ENGINE INDICATING - EGT HARNESS AND JUNCTION BOX - INTRODUCTION OF LONGER BOLT AT
CLIPPING POINT 7860 - CATEGORY CODE 6 - MOD.ENG-77-0008

V2500-ENG-77-0008

Location of EGT Harness, Junction Box and CP7860
Fig.1

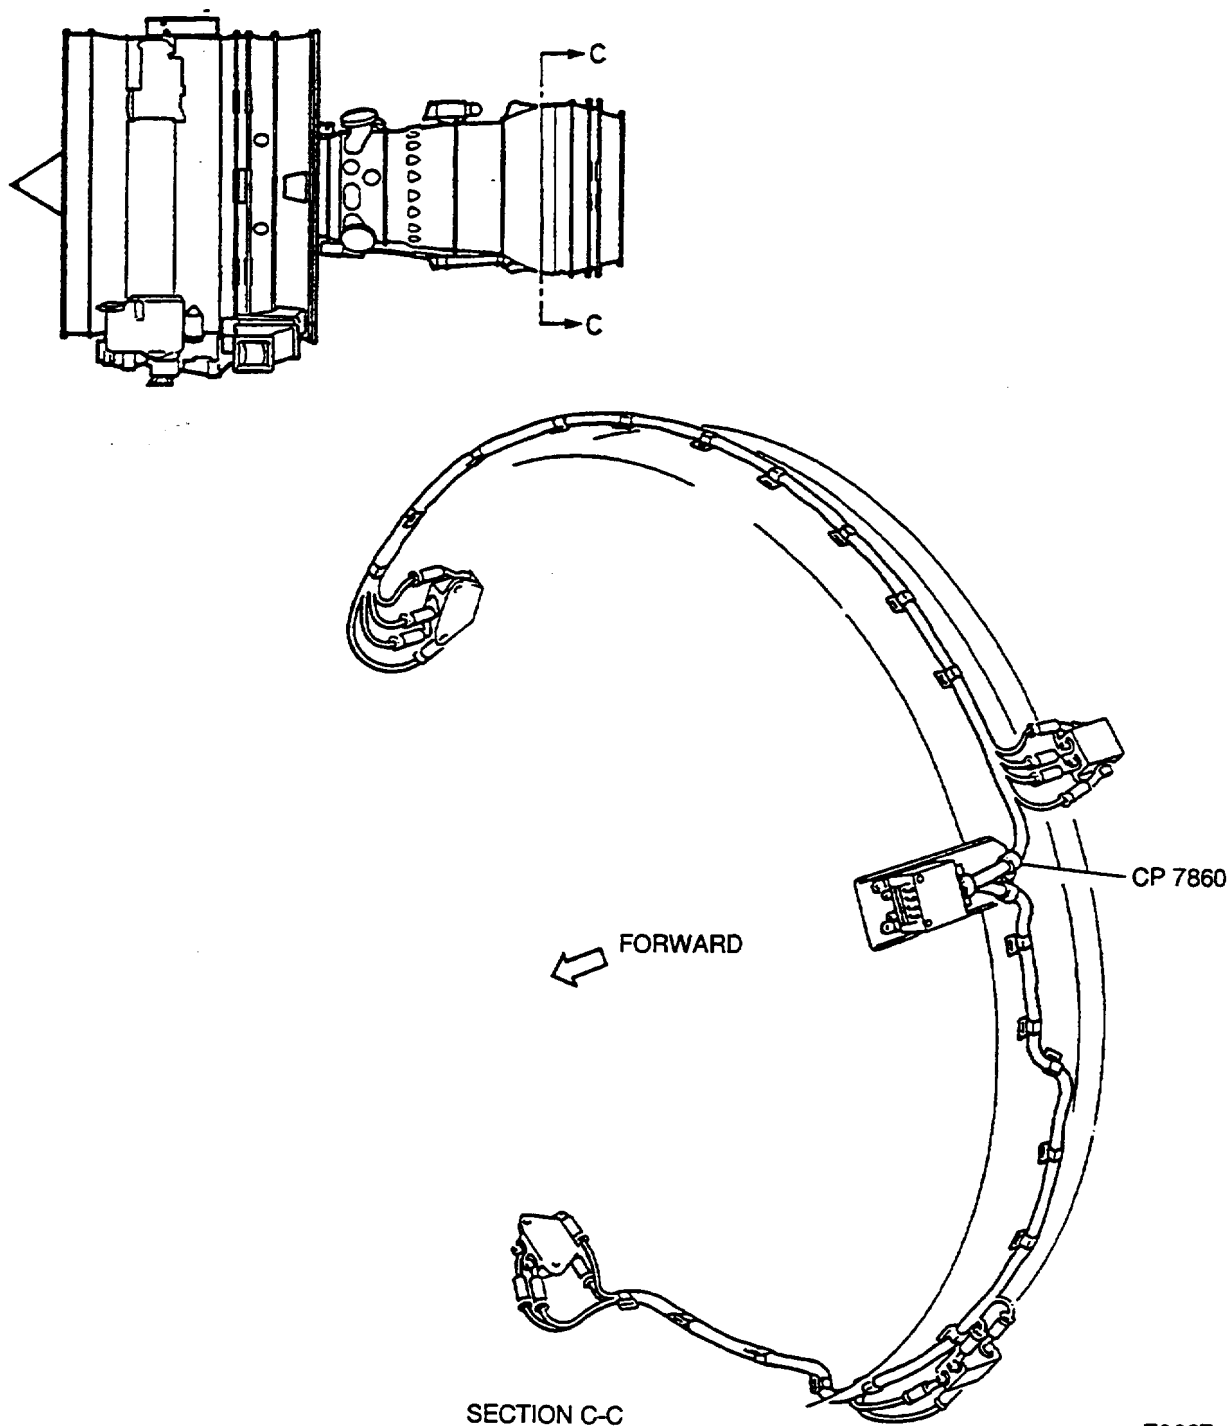
- (1) Find the E.G.T. mounting bracket for clipping point 7860. Refer to Figures 1 and 2.
- (2) Remove the 4W0103 bolt from clipping point 7860 and install new 4W0105 bolt. Torque the bolt to 36 to 45 lbfin (4 to 5 Nm). Refer to Figures 1 and 2.

Clipping point 7860 - Before and after alteration
Fig.2

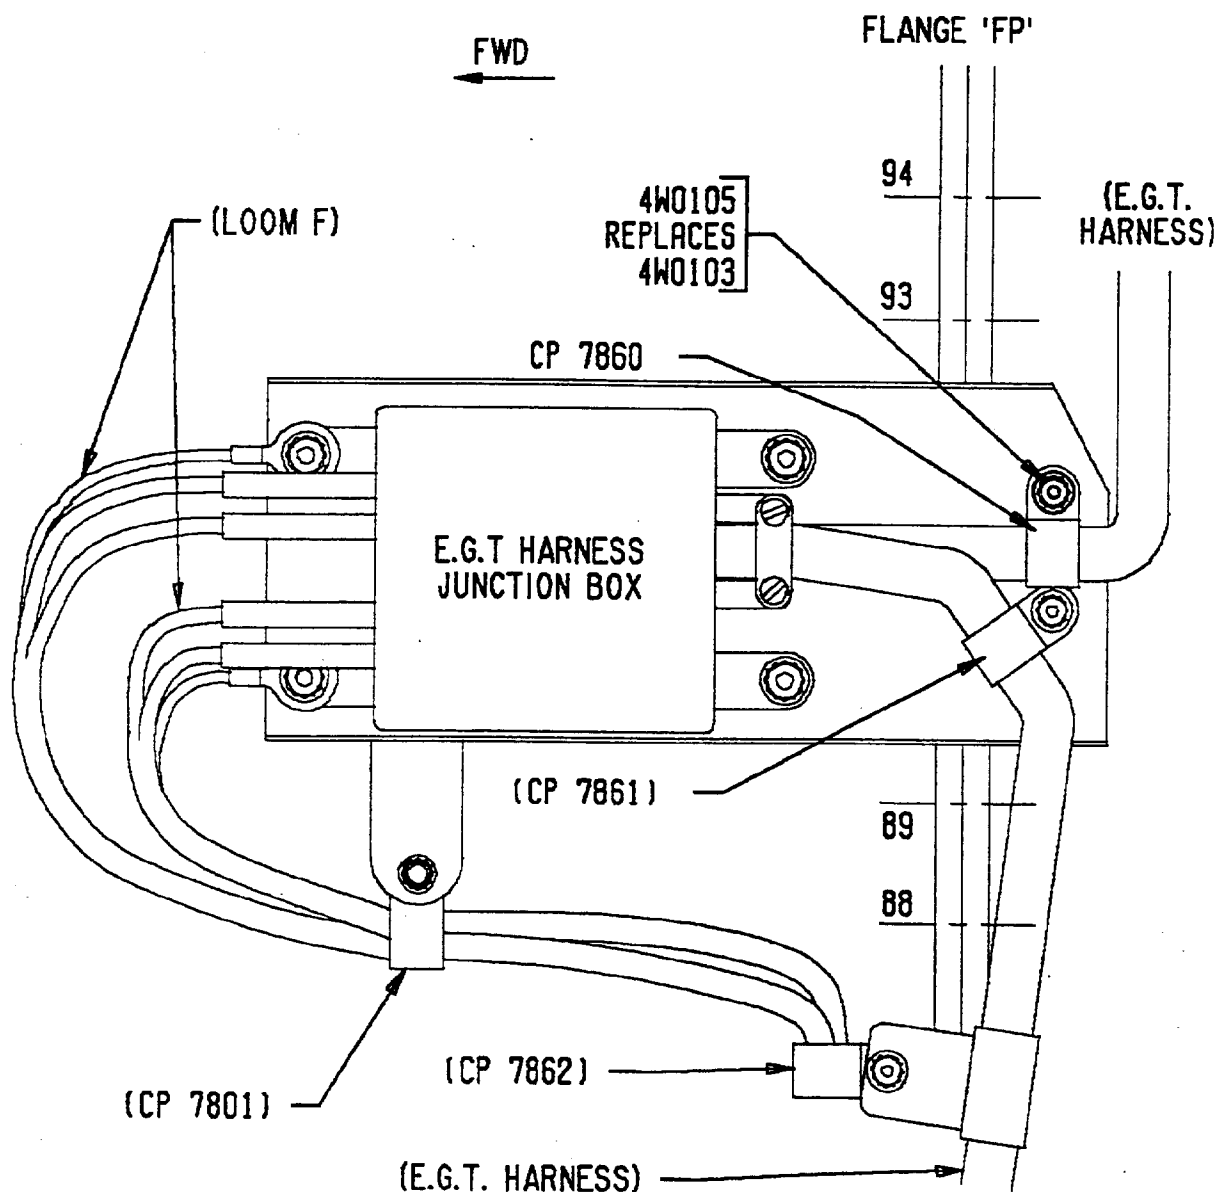
A longer bolt replaces the existing bolt at clipping point 7860.

VIEW ON E.G.T. HARNESS JUNCTION BOX
SHOWING CLIPPING POINT 7860
BEFORE AND AFTER ALTERATION
